Flood Control and Landfill Div.

- DP-104 - Oak Cliff Estates
Commercial & Residential C.U.P.

PROJECT: Oak Cliff Estates

REFERENCE: Drainage Plan and calculations

Chart 7

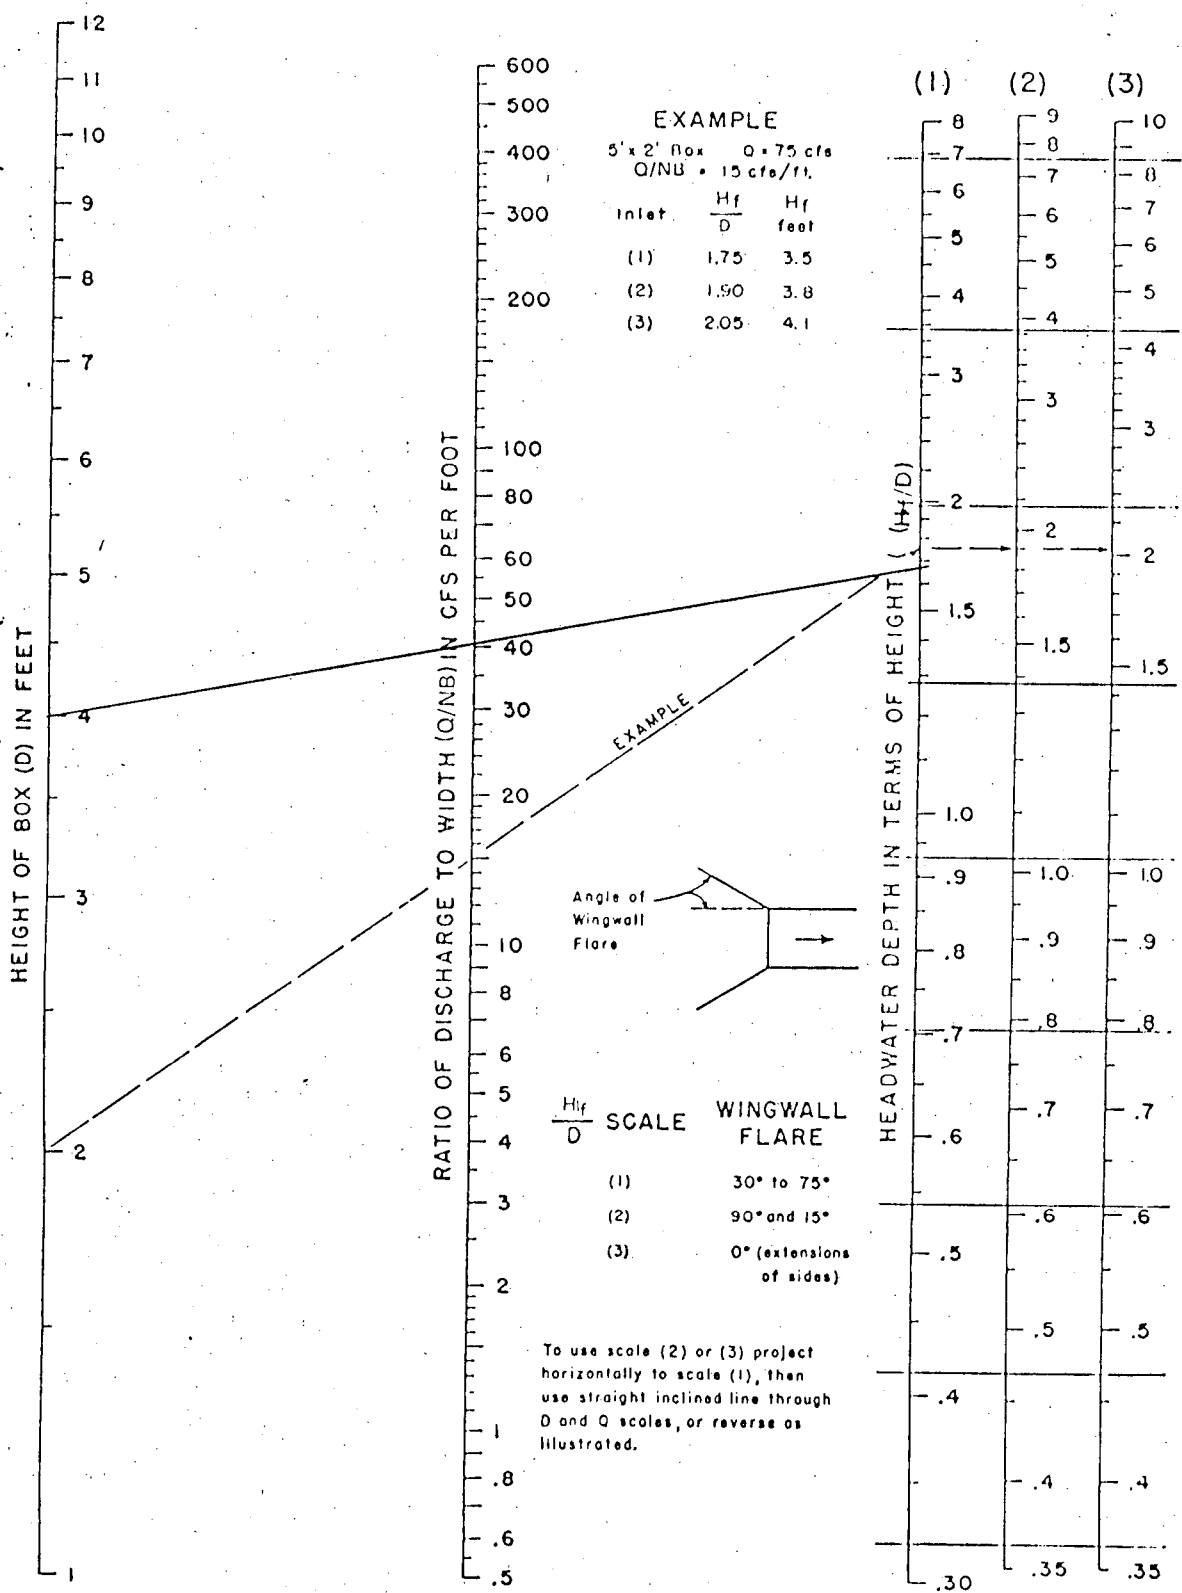
This means Maple will have 20" deep water, thus practically impossible to pass.

implies that detention is very important.

for 100 year frequency and considering 100 year storm the water should be 1 ft. below the top of Maple A if water tends to flow over maple for 100 year freq., detention should be provided so no street overtopping occurs.

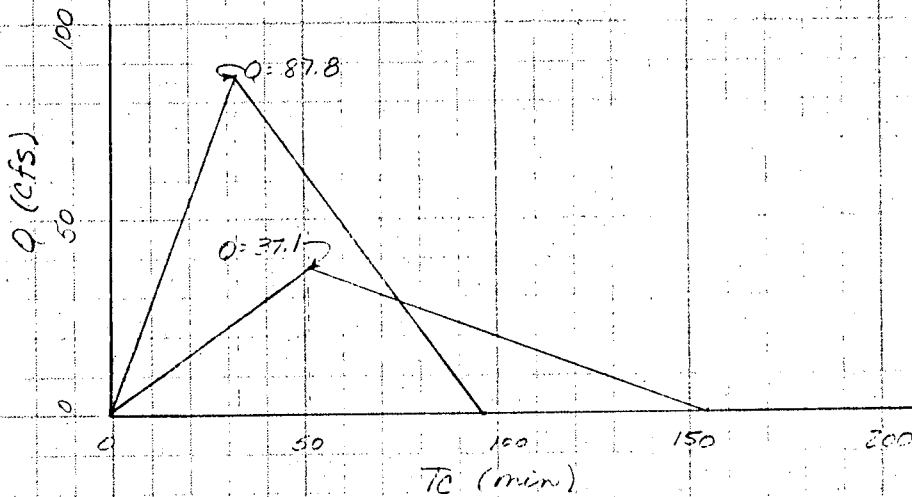
Pipe size at outlet - 60" ^{is not} ~~12.0~~ ^{the design water surface} el. in creek?

When the creek is in flood

actual slope available is negative; hence system will not work.

∴ pipe ≈ 1316.3 ; hence 6.7 feet ^{back} water on pipe.

∴ Flap gate structure absolutely necessary and of course storm water sewer system is ~~not~~ ^{ineffective} during high flows in river. An equalizing pond like that for Westlink 17th will improve storm
